BRACKETT AVE., PEAKS ISLAND

CITY OF PORTLAND, MAINE
Application for Permit to Install Wires

A.P.- 8711-5 Brackett Ave.
Peaks Island

Permit to construct 1-car frame garage 12'x20' at the above named location is being issued subject to the following requirements of the Building Code.

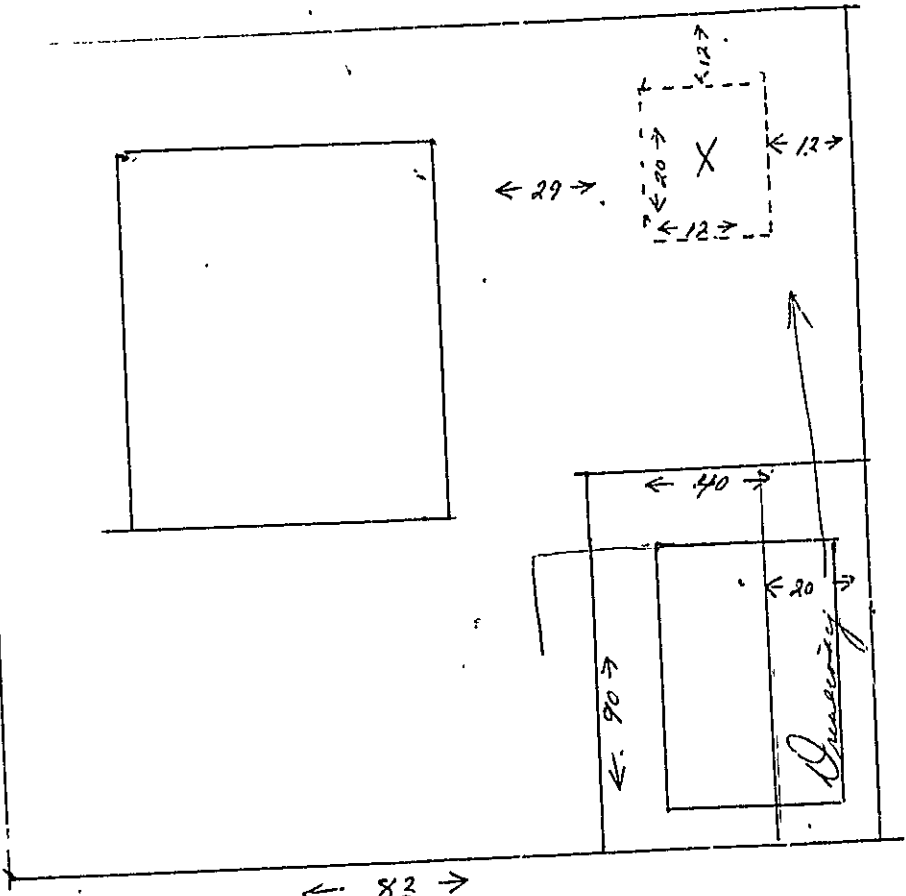
1. Ties of at least 2x4 inch stock will be required at every third rafter at the plate level and hung in the center by a board to the rafters, near the ridgeboard.
2. 2x8 inch floor joists will need to be spaced not more than 12 inches on centers instead of the 16 inches on centers stated on application or 2x10 inch floor joists may be used at 16 inches on centers if desired.
3. It is recommended that not less than 5/8 inch structural plywood be used for the sub-floor of this garage.
